Re: NPDES Permit No. IN0063711
ArcelorMittal Indiana Harbor, LLC –
Central Wastewater Treatment Plant
East Chicago, Indiana
Lake County

A response to the comments received pertaining to the draft NPDES permit is contained in the Post Public Notice Addendum. The Post Public Notice Addendum is located at the end of the Fact Sheet.

INDEX
for
ArcelorMittal Indiana Harbor Central Wastewater Treatment Plant NPDES Permit IN0063711

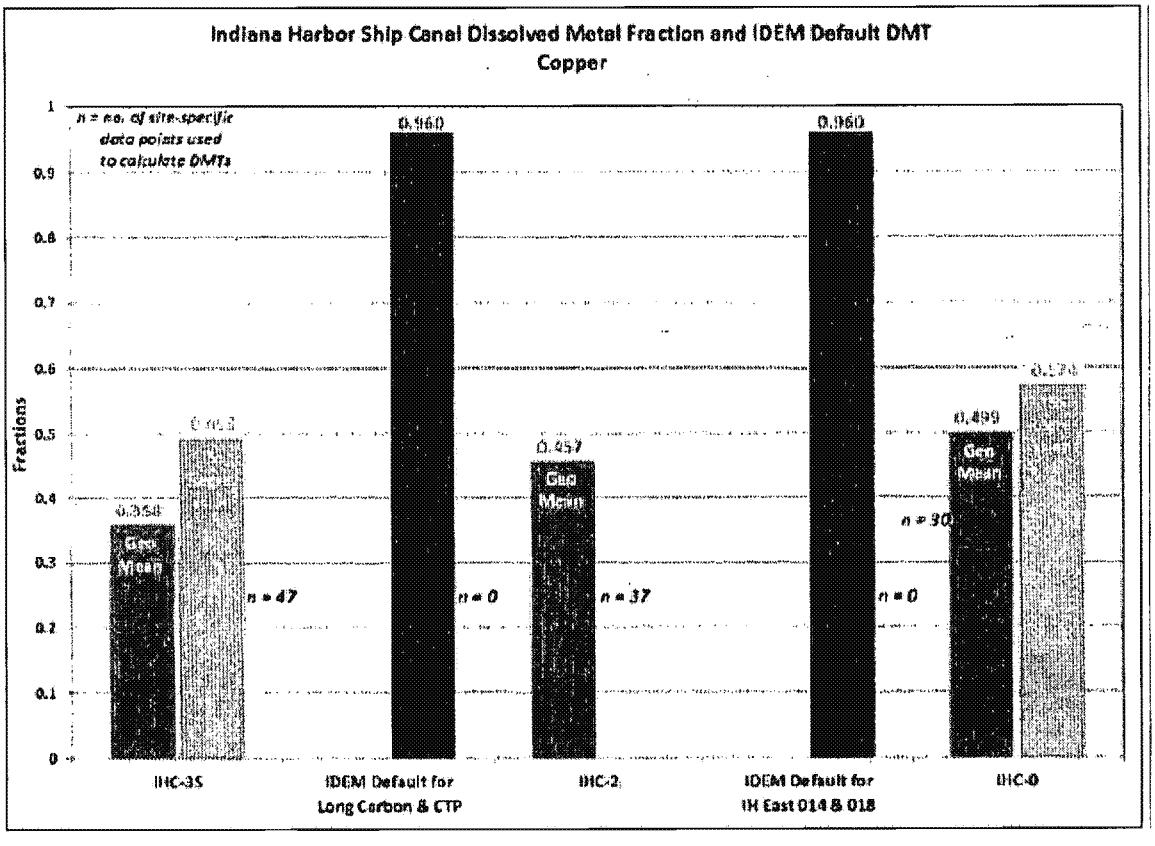
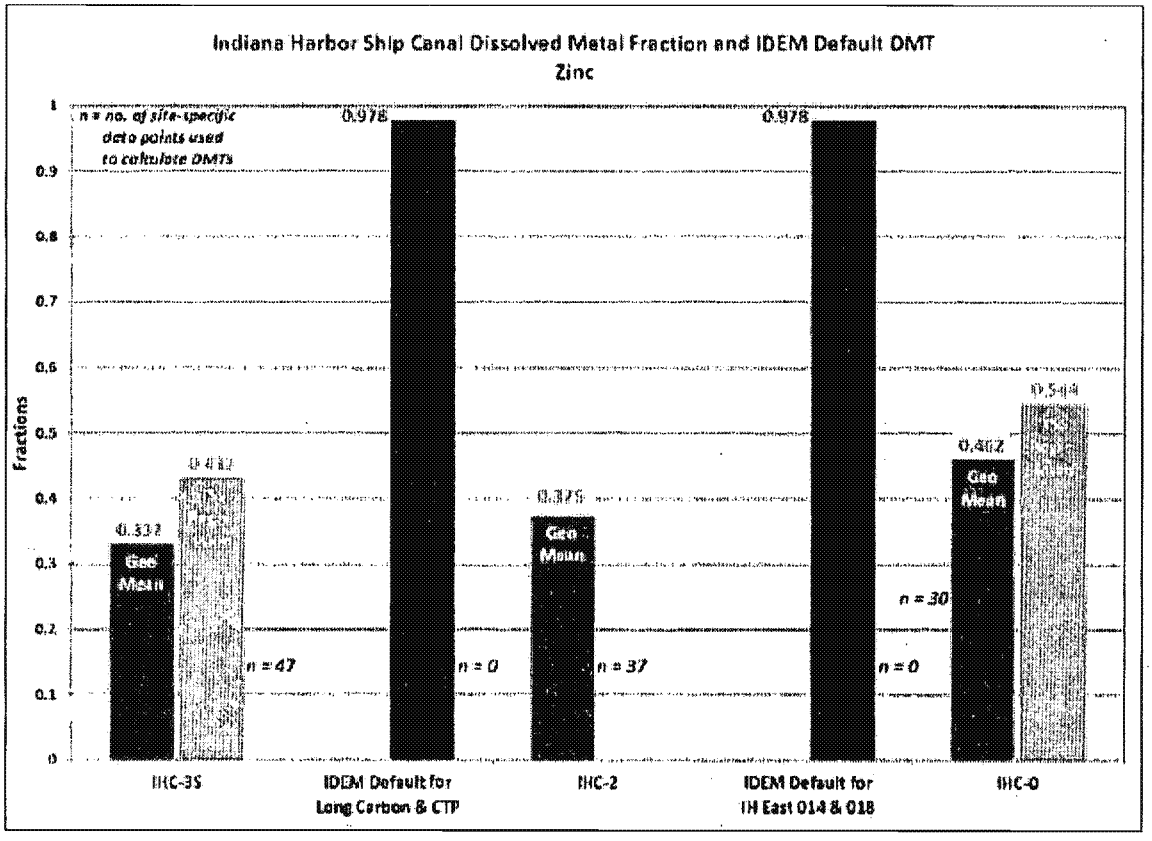
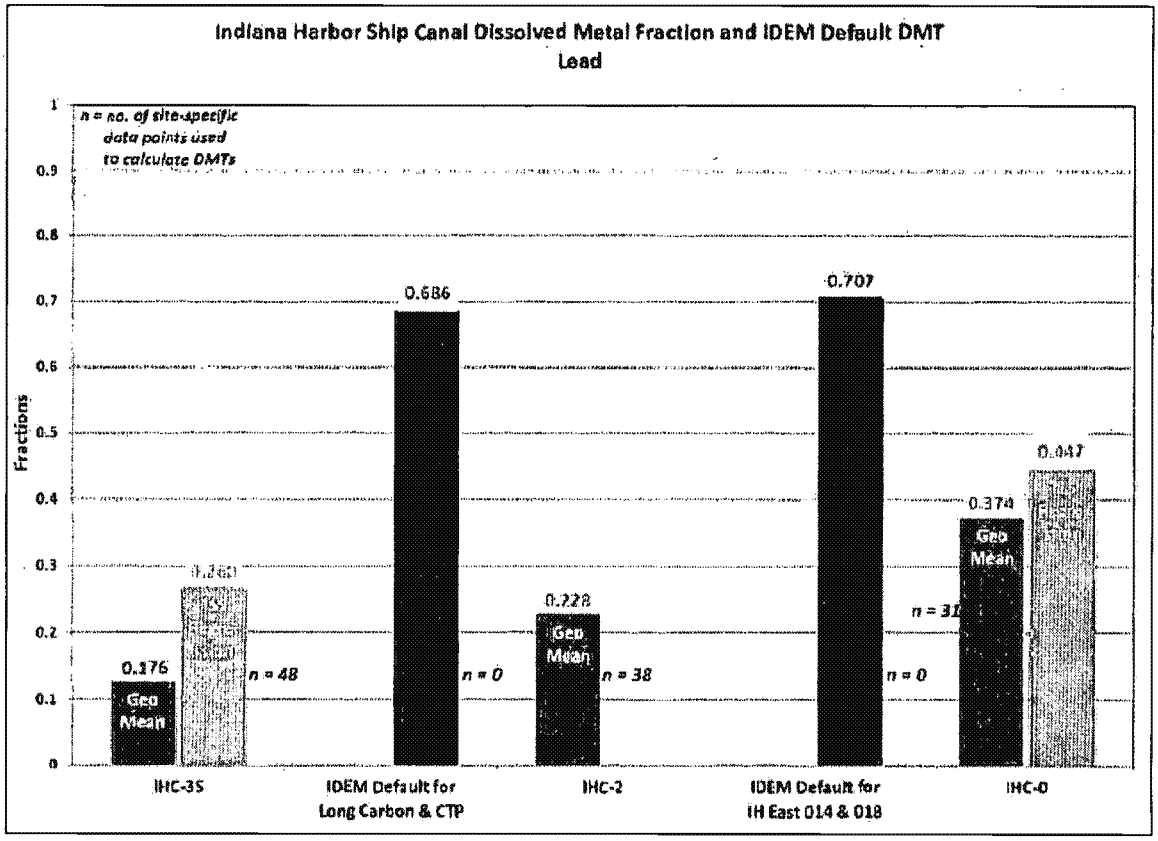
IDEM's default DMTs, which rely on no data specific to the IHSC, are clearly inaccurate for the ArcelorMittal permits and overestimate the dissolved copper, lead and zinc fractions in the IHSC by significant amounts. For example, the default translators are 2.1, 3.0 and 2.6 times greater than the calculated geometric mean of the dissolved fractions for copper, lead and zinc, respectively, at IHC-2. Even the 95th percentiles of the dissolved fractions for all metals at all locations are significantly below IDEM's default translators. As shown, the DMTs calculated at IHC-3S, IHC-2 and IHC-0 are considerably lower than IDEM's default DMTs used in the calculation of WQBELs. Graphs of the geometric mean dissolved fractions, TSS-regression developed DMTs, and IDEMs default DMTs are presented below.

Given the data presented in the table and graphs above, it is not reasonable to assume, as IDEM has done through use of the default DMTs, that the dissolved metal fraction in the water column somehow increases dramatically in between the fixed monitoring stations. ArcelorMittal's requested effluent limits, based upon site-specific DMTs derived from the IDEM fixed monitoring station data and other factors, are presented below.

1. WATER QUALITY-BASED EFFLUENT LIMITS (WQBELs)

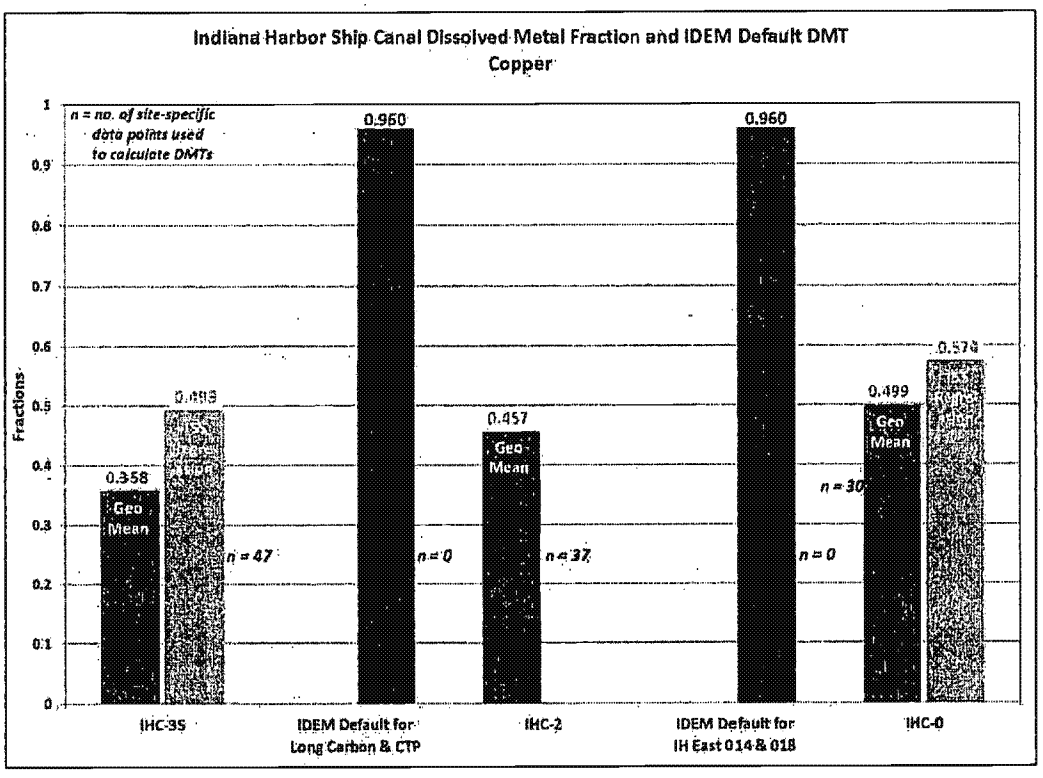
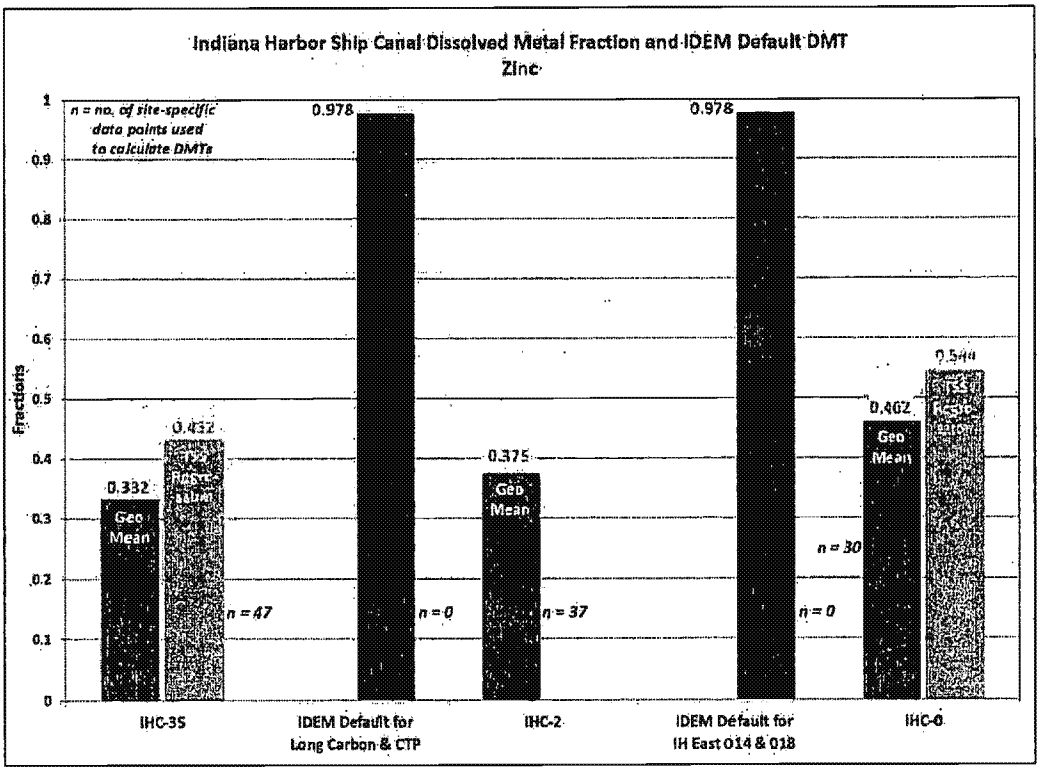
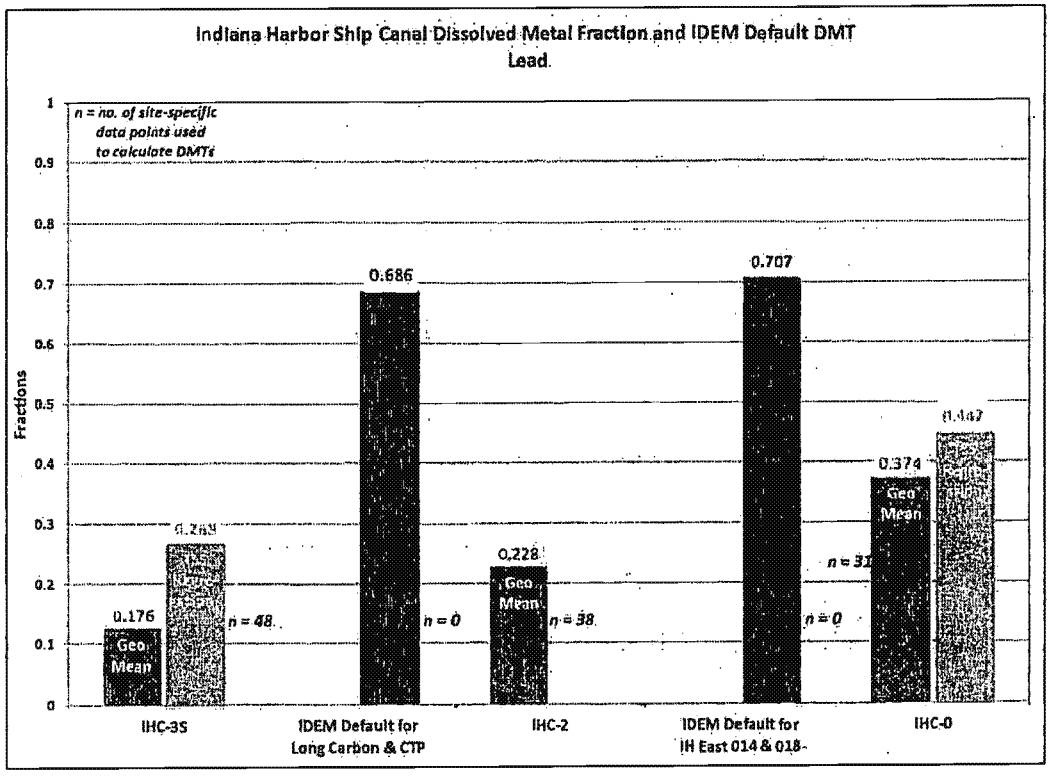
IDEM's default DMTs, which rely on no data specific to the IHSC, are clearly inaccurate for the ArcelorMittal permits and overestimate the dissolved copper, lead and zinc fractions in the IHSC by significant amounts. For example, the default translators are 2.1, 3.0 and 2.6 times greater than the calculated geometric mean of the dissolved fractions for copper, lead and zinc, respectively, at IHC-2. Even the 95th percentiles of the dissolved fractions for all metals at all locations are significantly below IDEM's default translators. As shown, the DMTs calculated at IHC-3S, IHC-2 and IHC-0 are considerably lower than IDEM's default DMTs used in the calculation of WQBELs. Graphs of the geometric mean dissolved fractions, TSS-regression developed DMTs, and IDEMs default DMTs are presented below.

Given the data presented in the table and graphs above, it is not reasonable to assume, as IDEM has done through use of the default DMTs, that the dissolved metal fraction in the water column somehow increases dramatically in between the fixed monitoring stations. ArcelorMittal's requested effluent limits, based upon site-specific DMTs derived from the IDEM fixed monitoring station data and other factors, are presented below.

FIGURE IHW-1

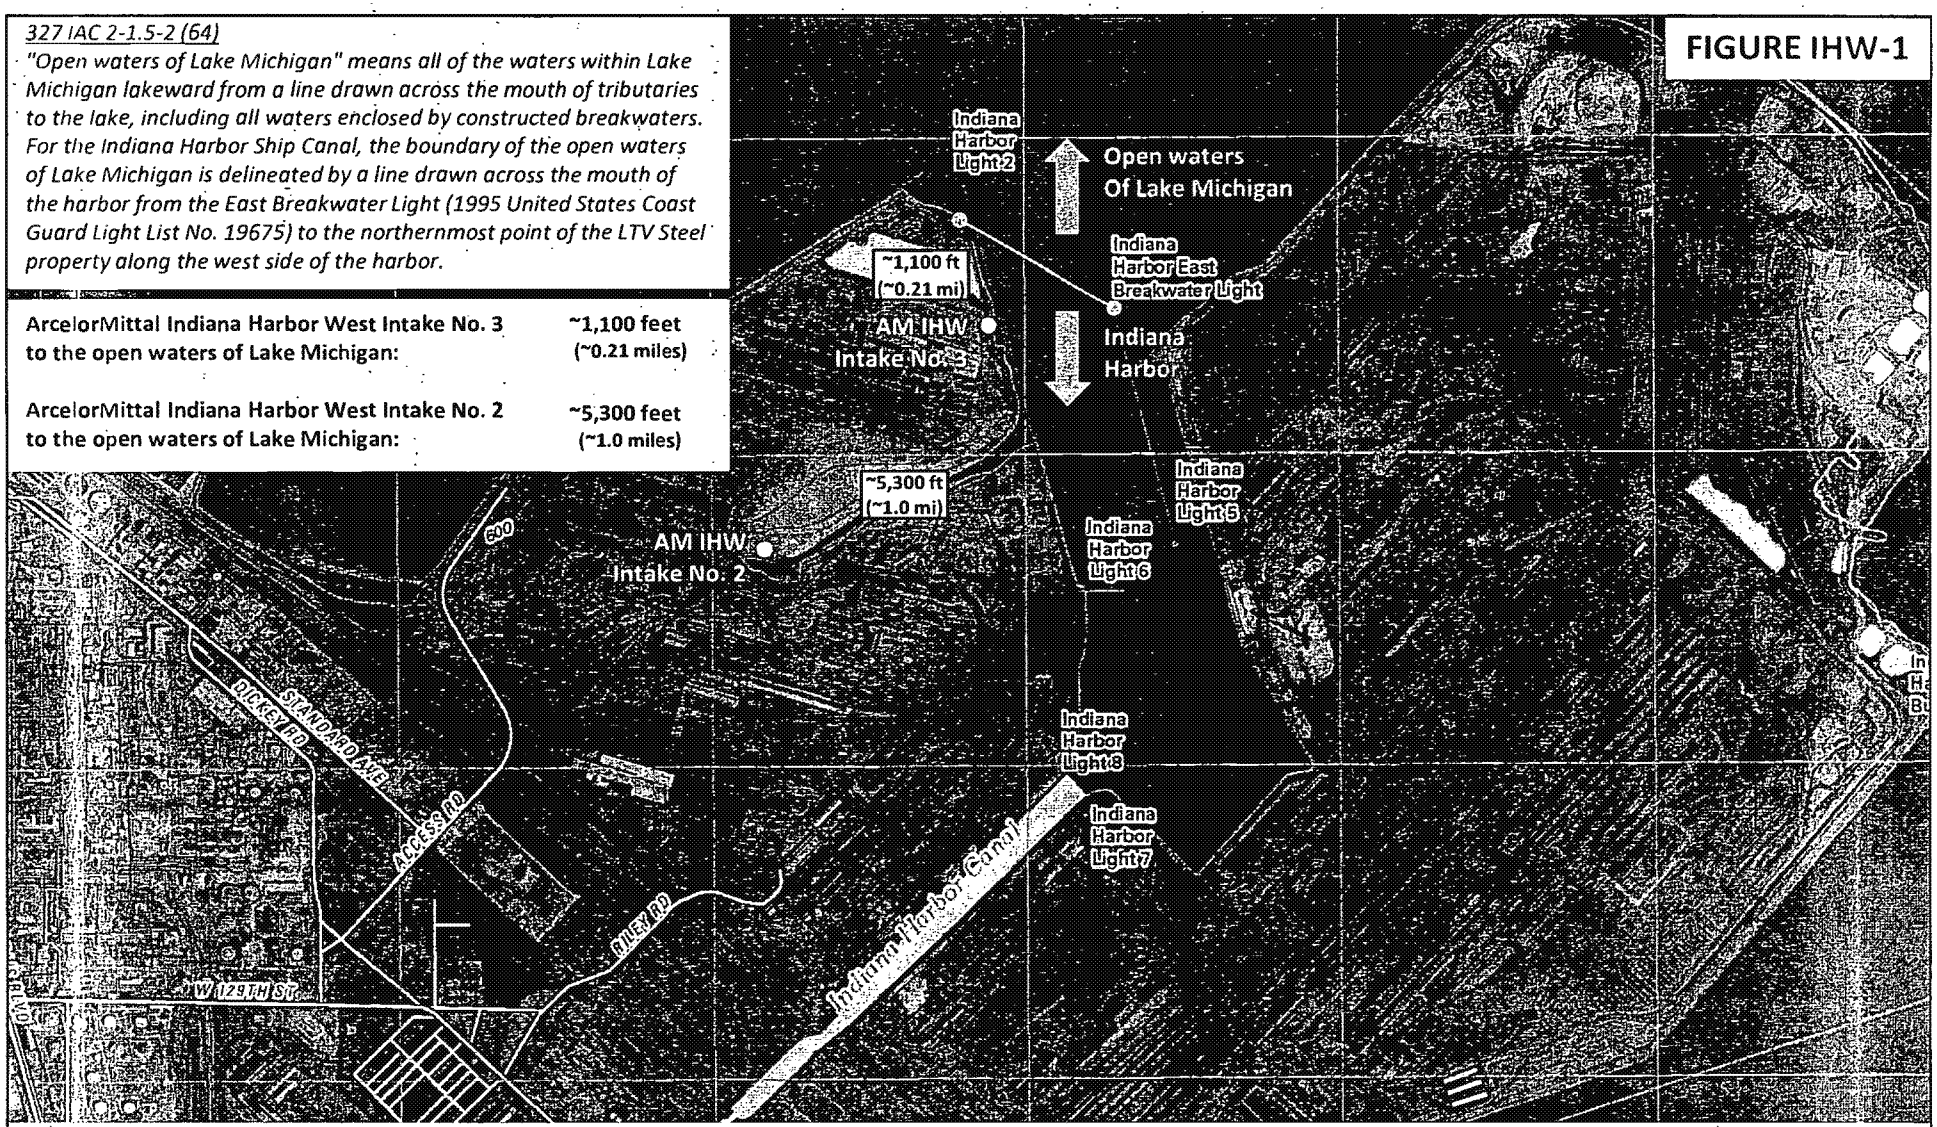
IDEM states in Attachment A of the Fact Sheet (p. 5), that Indiana Harbor West has two water intakes in Lake Michigan; and, that IDEM considers the intake channel for the Nos. 2 and 3 intakes as "open waters of Lake Michigan" (p. 12). Figure IHW-1 is an aerial photograph showing the Nos. 2 and 3 intakes, the intake channel and the northern section of the Indiana Harbor Ship canal that borders the open waters of Lake Michigan. A line depicting the boundary described in the above definition of "open waters of Lake Michigan" is shown on the aerial photograph. It is evident from a simple reading of the regulatory definition of "open waters of Lake Michigan" and review of the aerial photograph that the Indiana Harbor West intake channel and the Nos. 2 and 3 intakes are not within open waters of Lake Michigan. They are not lakeward of the line between the East Breakwater Light and the northernmost point of LTV Steel property (now ArcelorMittal Indiana Harbor LLC property). In fact, the No. 3 Intake is approximately 0.21 miles south of the northernmost point of ArcelorMittal property and the No. 2 intake is approximately 1.0 miles south and southwest of the northernmost point of ArcelorMittal property. Thus, IDEM's assertion that the intake channel for the Nos. 2 and 3 intakes are within the

ArcelorMittal Indiana Harbor West Intake No. 3 to the open waters of Lake Michigan:	~1,100 feet (~0.21 miles)
ArcelorMittal Indiana Harbor West Intake No. 2 to the open waters of Lake Michigan:	~5,300 feet (~1.0 miles)
